CONSTRUCTION SUMMARY  
2185715 Ontario Inc.

LOT NUMBER	PHASE	HOUSE TYPE	CLOSING DATE	
023	1	ALEXIE-STD MAIN-4 BEDROOM-ELEVATION A	13-Sep-22

Date Added: 02-May-22

Invoice Number: 7837

LOWER LEVEL  
ELEV. A, B & C

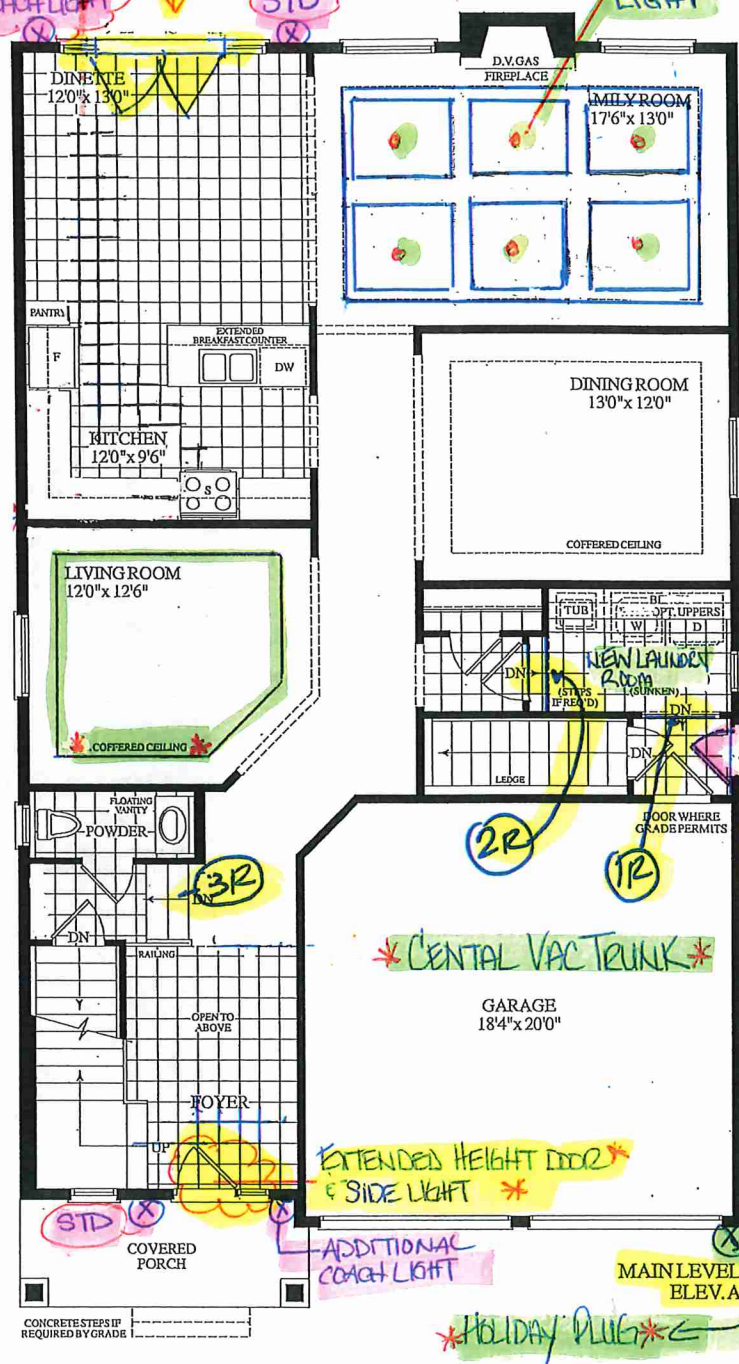
<p>1 - SIDE DOOR- Install exterior Side door with applicable Coach Light (See Sketch)</p> <p>Note:</p>
<p>2 - BASEMENT- Install larger basement windows, in lieu of the builders standard 30"x16". Install TWO (X2) 30"x24" windows in the basement (See Sketch) (With Possible Window wells)</p> <p>Note:</p>
<p>3 - BASEMENT- Install larger basement windows, in lieu of the builders standard 30"x16". Install THREE (X3) 36"x24" windows in the basement (See Sketch) (With Possible Window wells)</p> <p>Note:</p>
<p>1 - BASEMENT- In addition to the basement windows, Install ONE larger basement window. (See Sketch) (With Possible Window wells)</p> <p>Note:</p>
<p>15 - SECOND FLOOR- Install Extended Height 8'-0" Interior doors, throughout second floor, where applicable (Standard door style only) Install a total of (X15) doors</p> <p>Note:</p>
<p>1 - BACK EXTERIOR DOORS- Delete the builders standard Patio sliders and Install Extended Height double French doors with applicable side lights (See Sketch)</p> <p>Note: Approx. 99" x 99" R/O</p>

- POT FILLER OVER STOVE
- 8" EXHAUST DUCT FOR STOVE

MAIN LEVEL  
ELEV. A

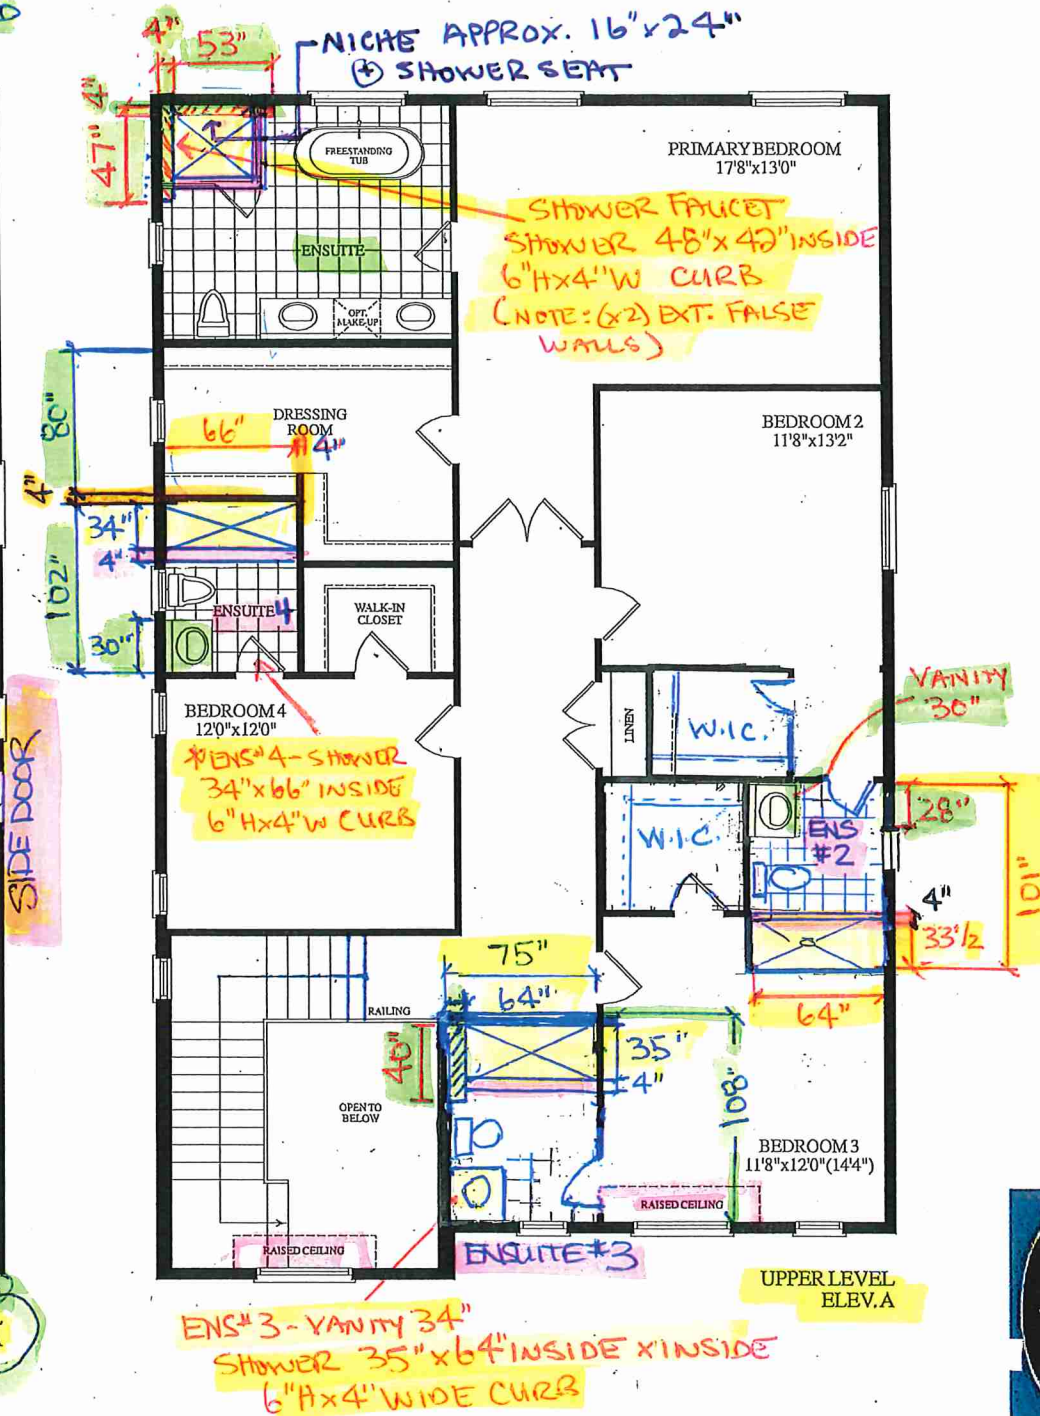
<p>1 - EXTERIOR FRONT DOOR- Install an extended height front door and side light. Delete the transom above to accommodate. (See Sketch)</p> <p>Note:</p>
<p>1 - LAUNDRY ROOM- Relocate all existing standard laundry Rough In to the Mudroom on Main Floor. To include electrical for washer, dryer and relocate the builders standard existing Laundry Tub (See Sketch)</p> <p>Note:</p>
<p>1 - KITCHEN- Install an 8" Duct for stove exhaust fan , in lieu of the builders standard 6" (See Sketch)</p> <p>Note:</p>
<p>1 - MINIMUM CHARGE FOR ANY CHANGE TO STRUCTURE/FLOORPLAN</p> <p>Note:</p>
<p>1 - BEDROOM #3 ENSUITE-Convert original 2nd floor laundry room to a 3pce bathroom at bedroom #3. To include standard Vanity, builders standard toilet, tub/shower and standard plumbing, applicable bathroom fan. (See Sketch)</p> <p>Note: **Close off entrance to original laundry room at upper hall- Door to be reloacted to Bedroom #3 Ensuite</p> <p>    **Install Void space if needed**</p> <p>    Priced As Per Steve</p> <p>    Approved As Per Tony</p>

\* EXTENDED HEIGHT FRENCH \* RD. 99" x 99"  
DOORS + SIDE LIGHTS

books + side lights

ADD COACH LIGHT

\*6-POTS  
DELETE STD  
LIGHT
